Office Action Summary	Application No. 10/711,487	Applicant(s) JOSHI ET AL.	
	Examiner Sunil Singh	Art Unit 3672

DETAILED ACTION

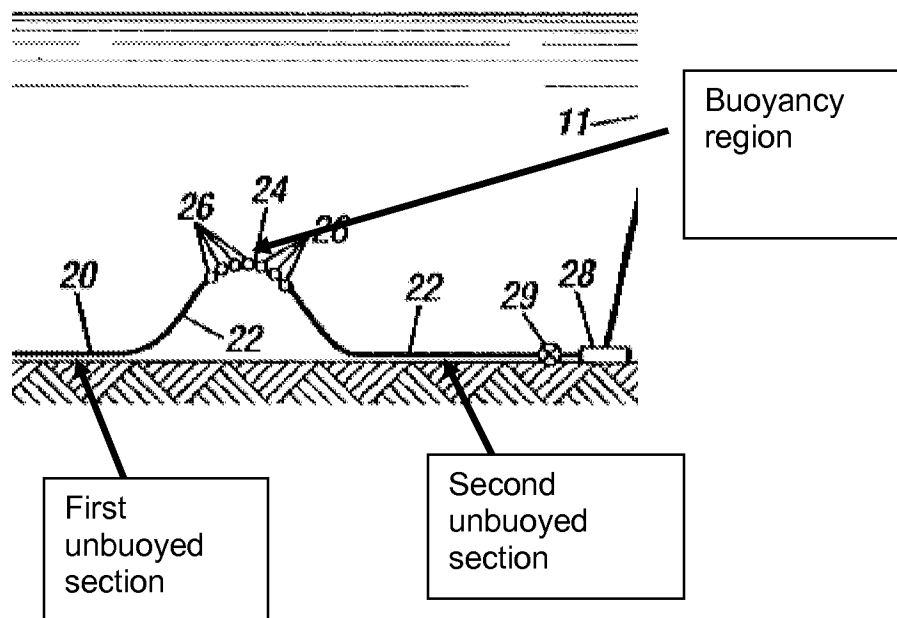
2. Claims 66-68,71,72 are rejected under 35 U.S.C. 102(b) as being anticipated by Richmond et al. (US 5582252)

Richmond et al. discloses a pipeline comprising a first unbuoyed section (see drawing below, Fig. 2), second unbuoyed section (see drawing below, Fig. 2), at least one buoyancy section (24,26) disposed between the first and second sections.
